**EA1415-01 Phase 2 Risk Assessment Technical Report Cover Letter
Prairie Creek All Season Road**

Attn. Mr. Chuck Hubert
Environmental Assessment Officer
Mackenzie Valley Environmental Impact Review Board
Box 938, 5102-50th Ave,
Yellowknife, NT X1A 2N7

Cross section example: 7 m "vertical fall" and high cut in rock at km 36.9. Implementation of berms/barriers downhill-side, gabions uphill-side seems difficult due to the lack of space.

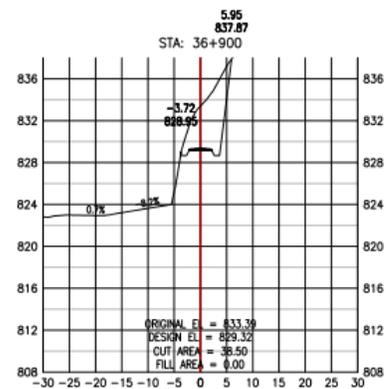
- 1) hauling concentrate and environmentally significant loads has a very different potential impact than hauling wood logs (e.g. increases the risk because the consequence part of the risk equation is increased).
- 2) The narrow roadbase will make it very difficult (impossible?) to install barriers or berms (to avoid vehicles to "fall off" the road) in areas that would require them (See cross section example figure).
